February 1, 2023

Lenoir County Administration Building – Interior Renovation

ADDENDUM NO. 2

Sheet M1.2

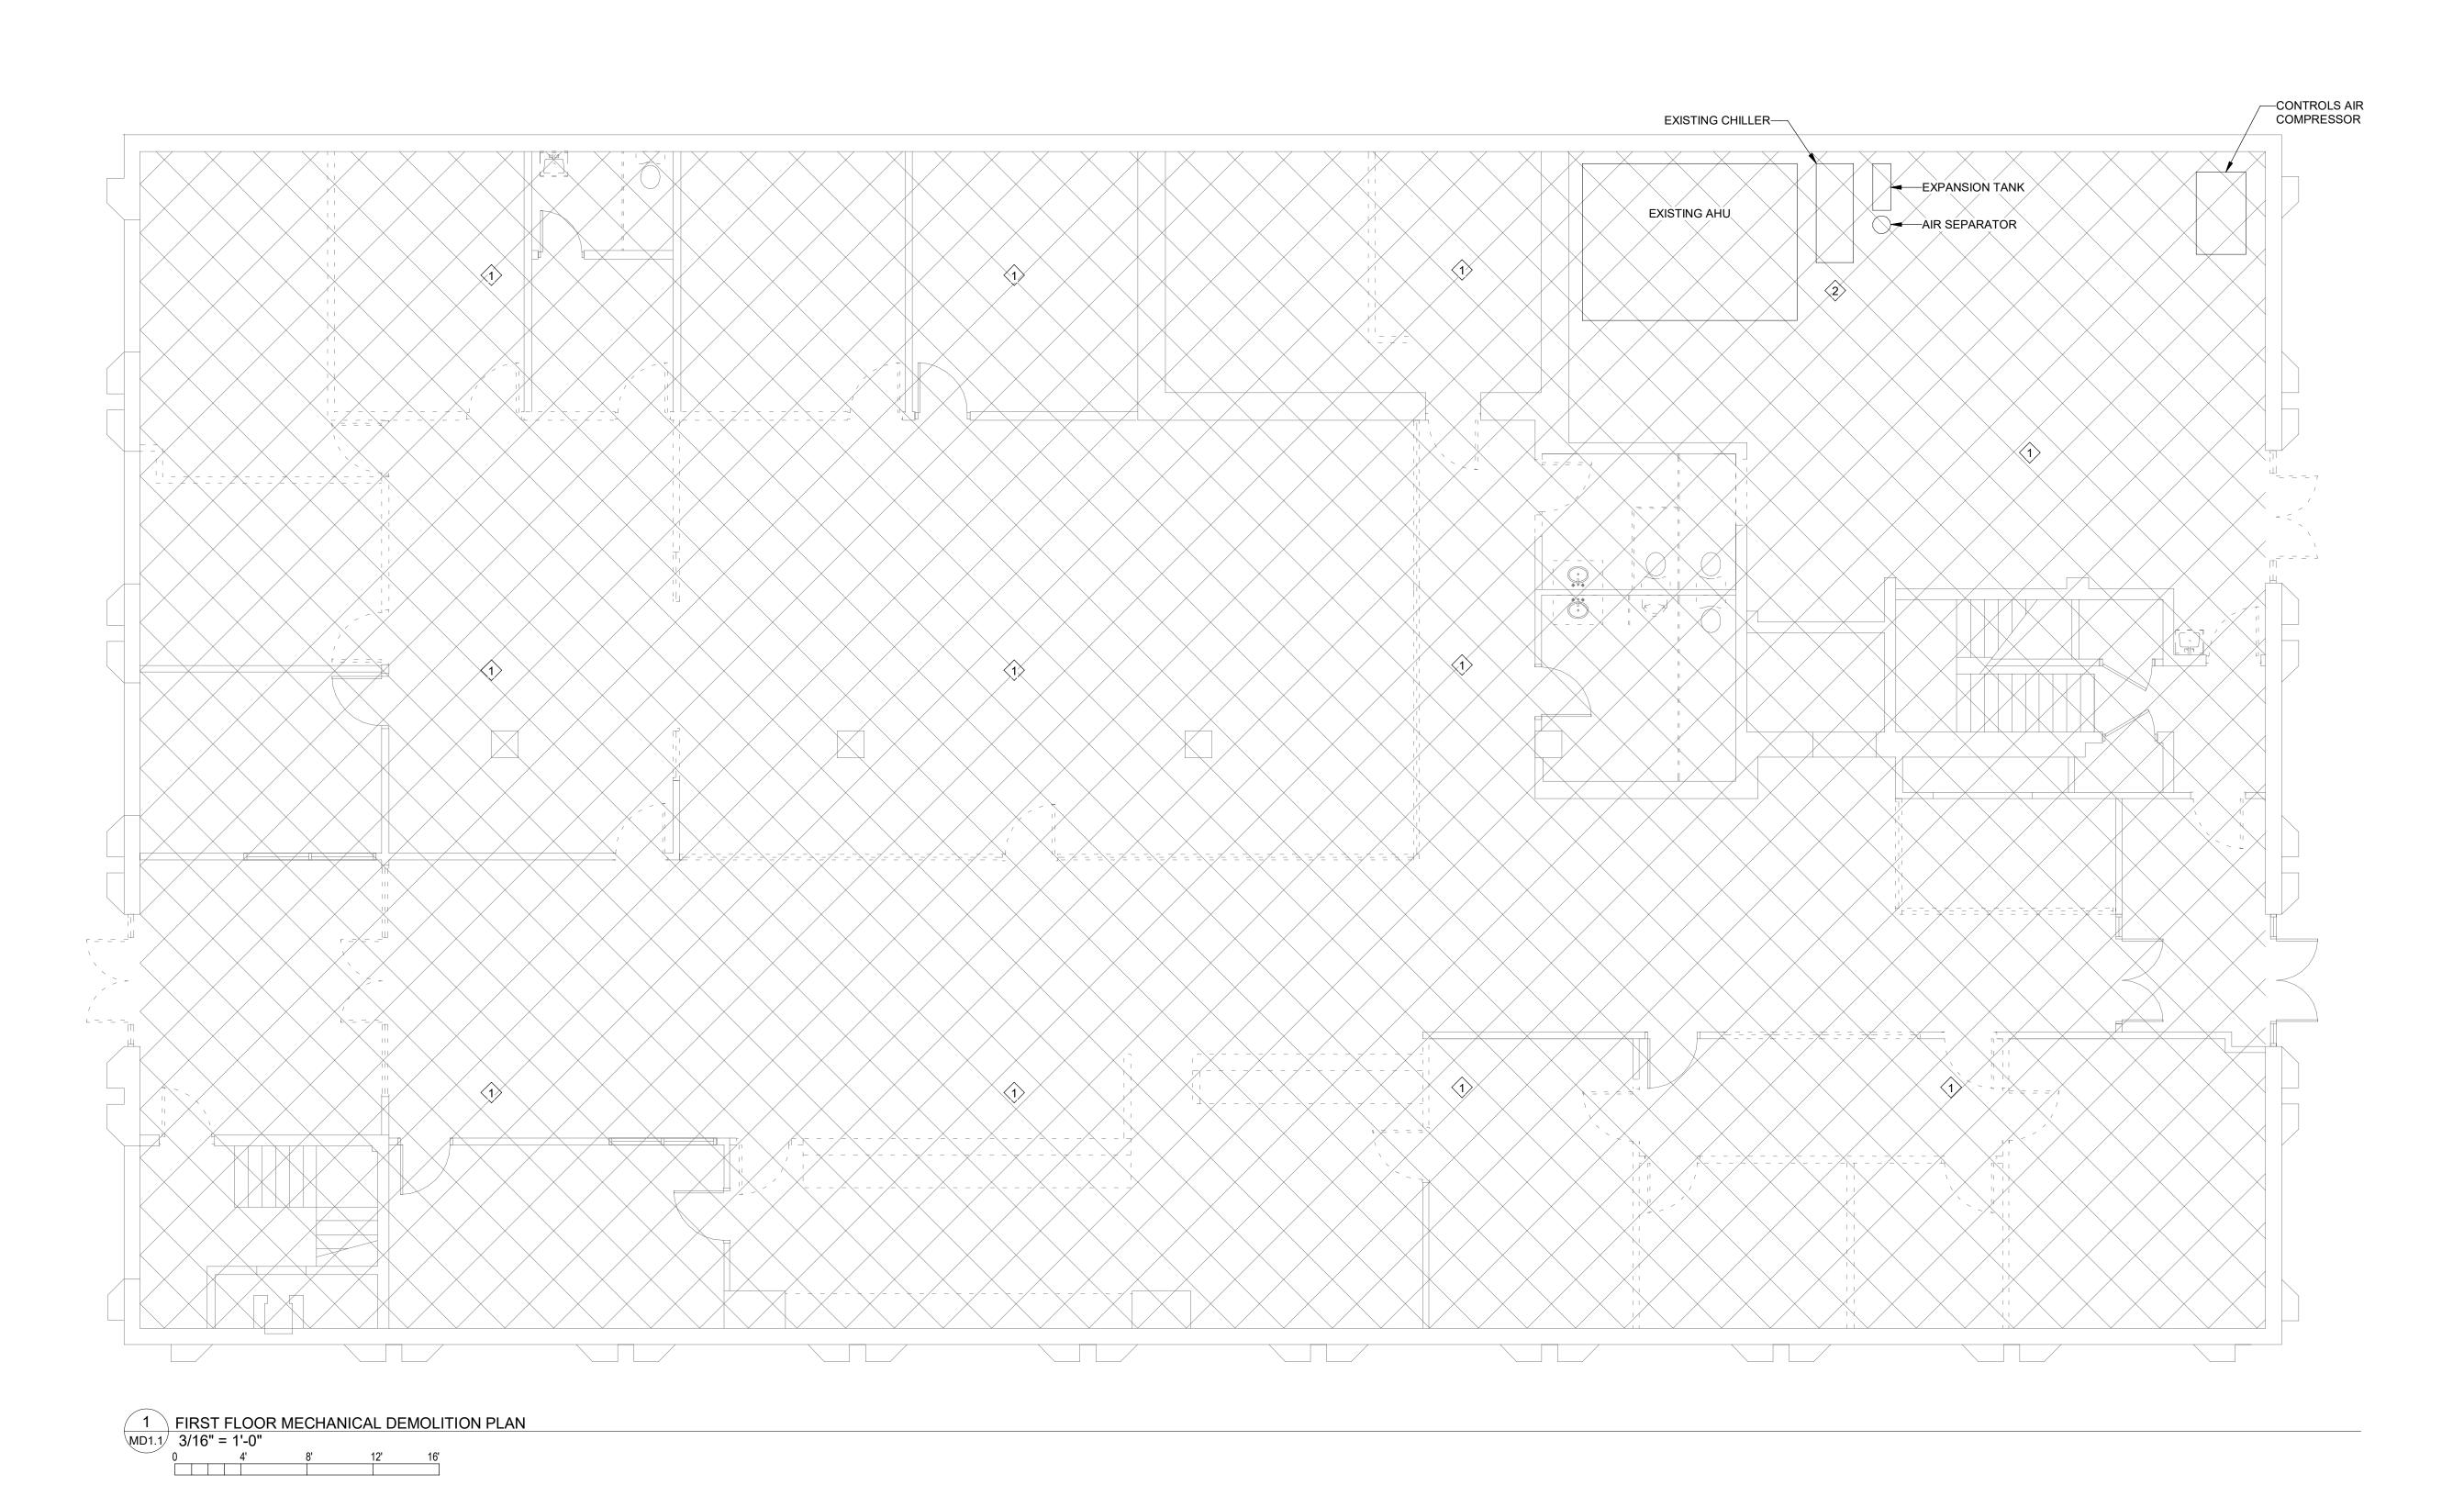
Removed demolition notes from sheet.

Sheet MD1.1

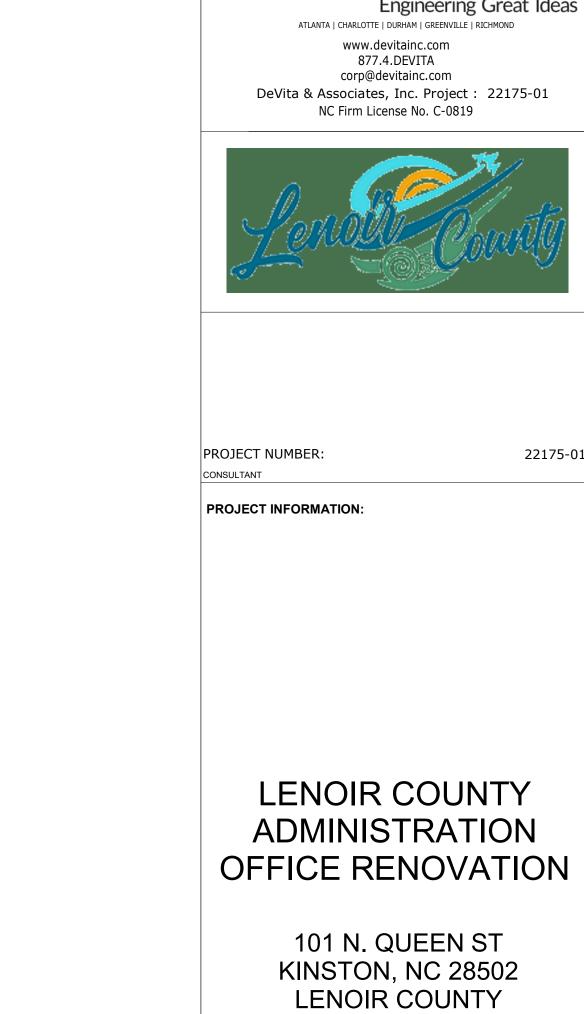
• Added sheet for mechanical first floor demolition plan to set.

Sheet MD1.2

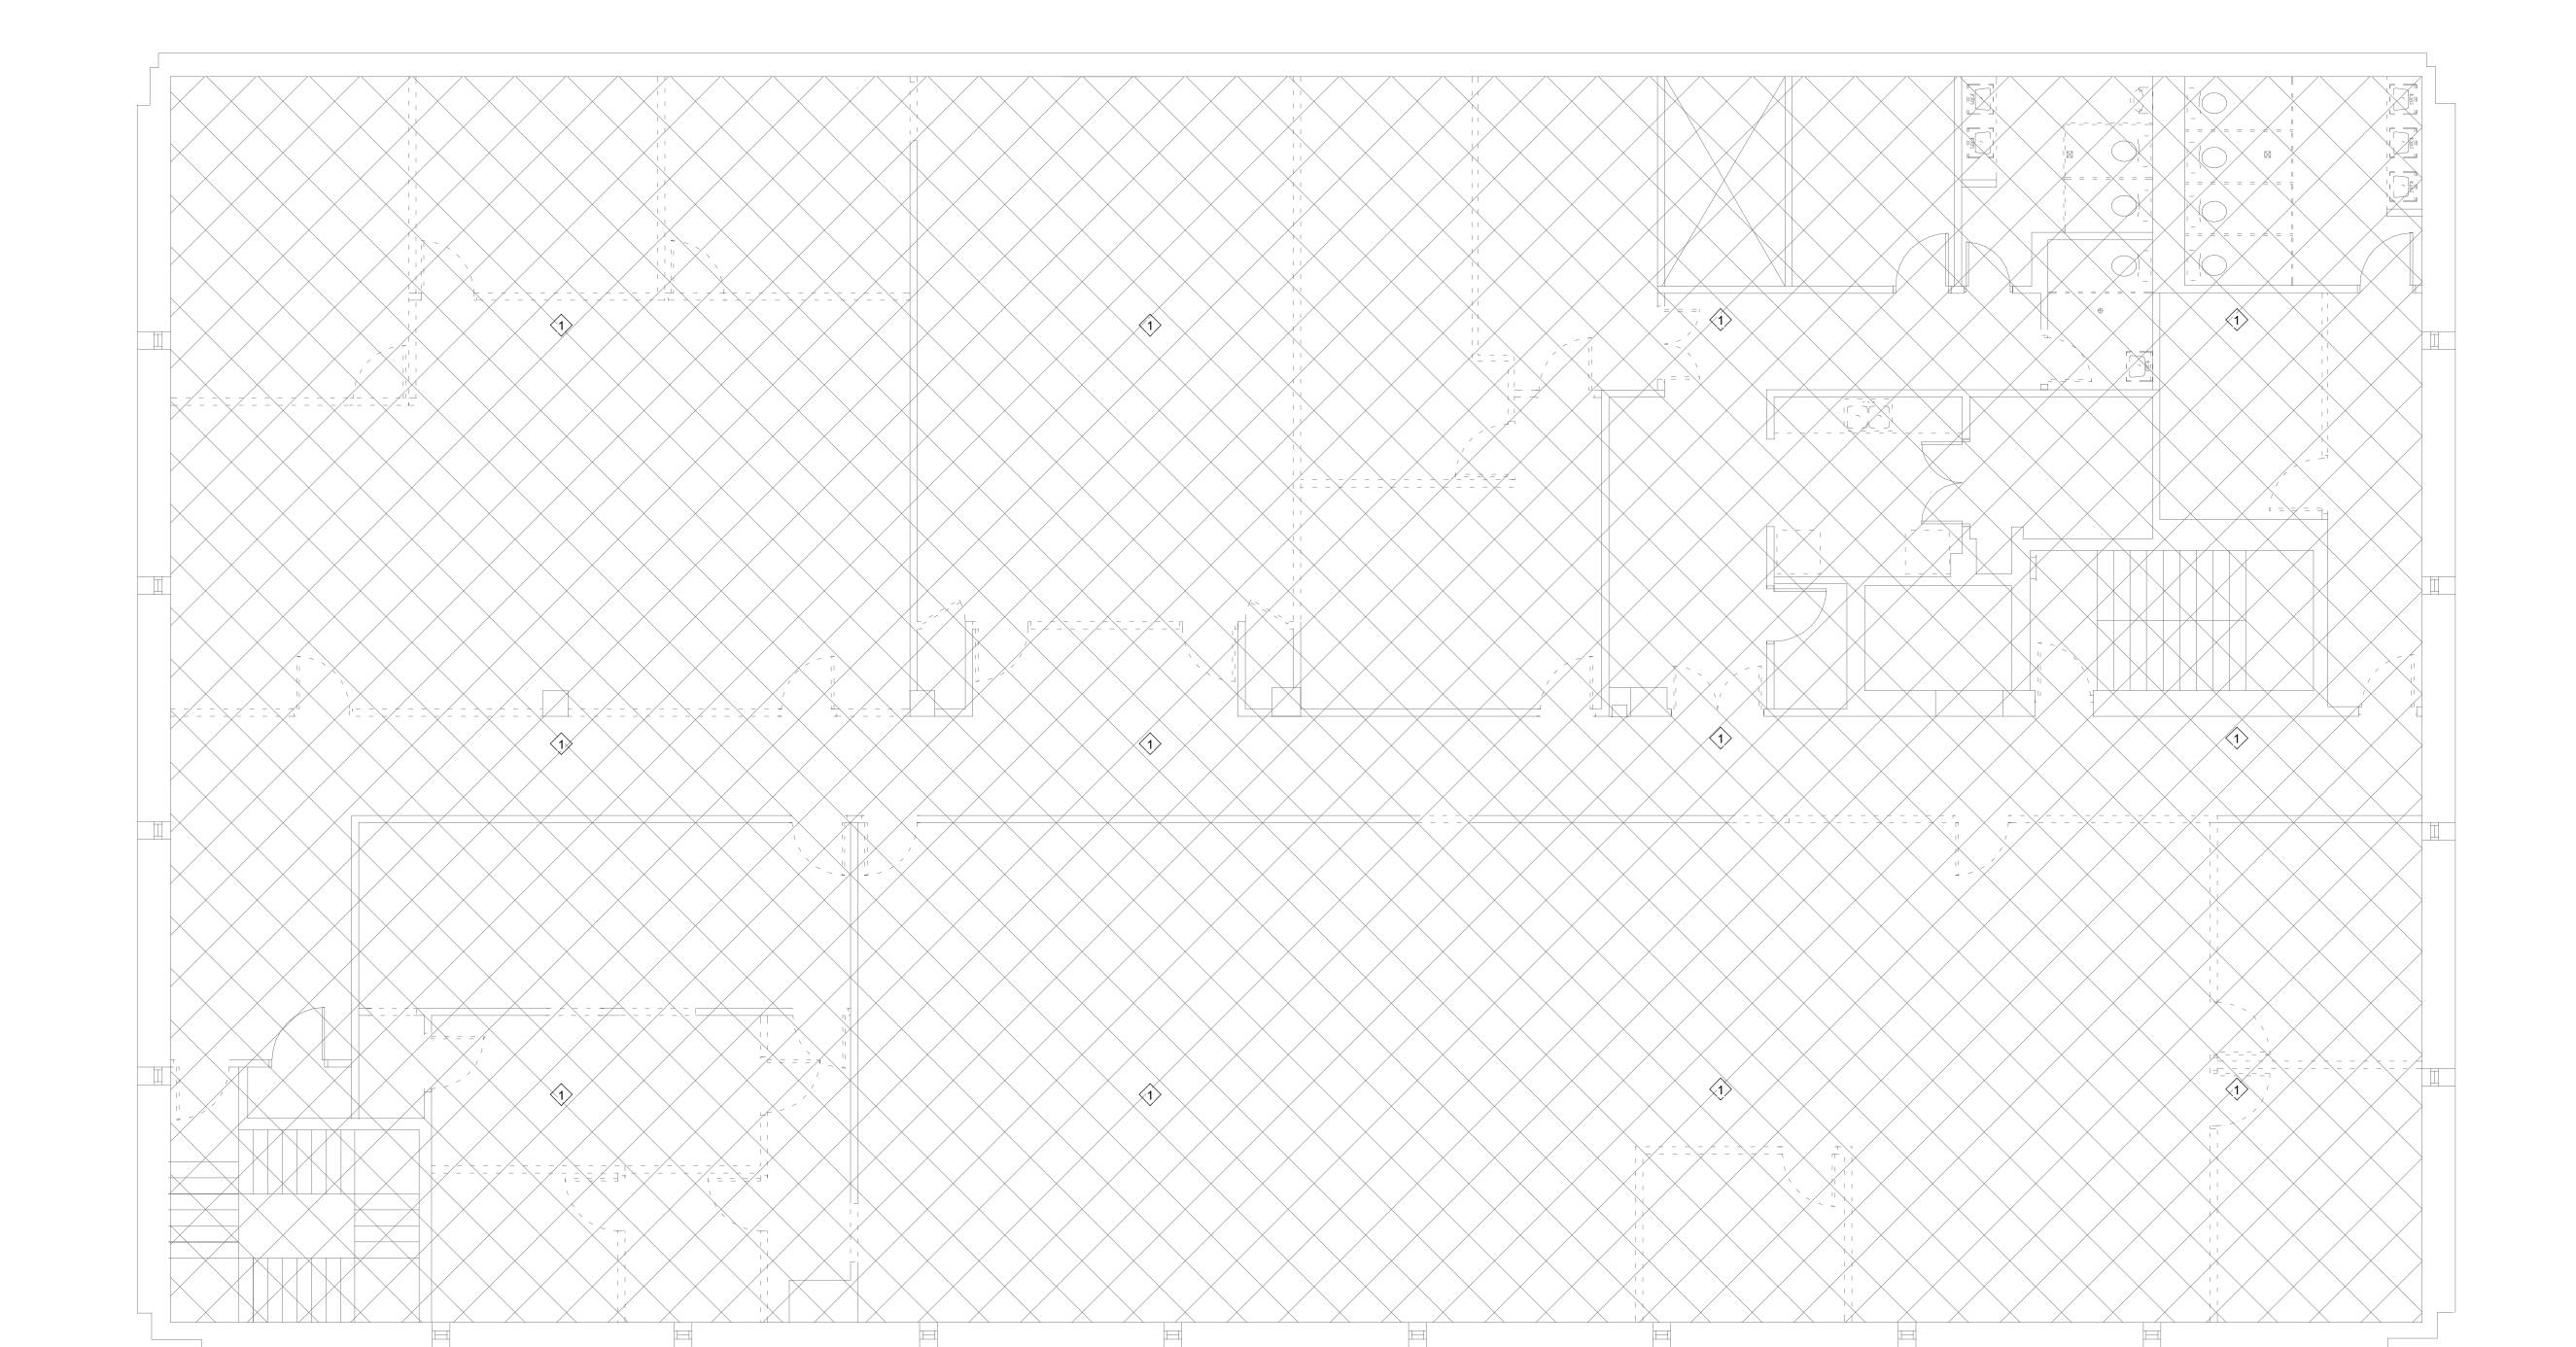
• Added sheet for mechanical second floor demolition plan to set.
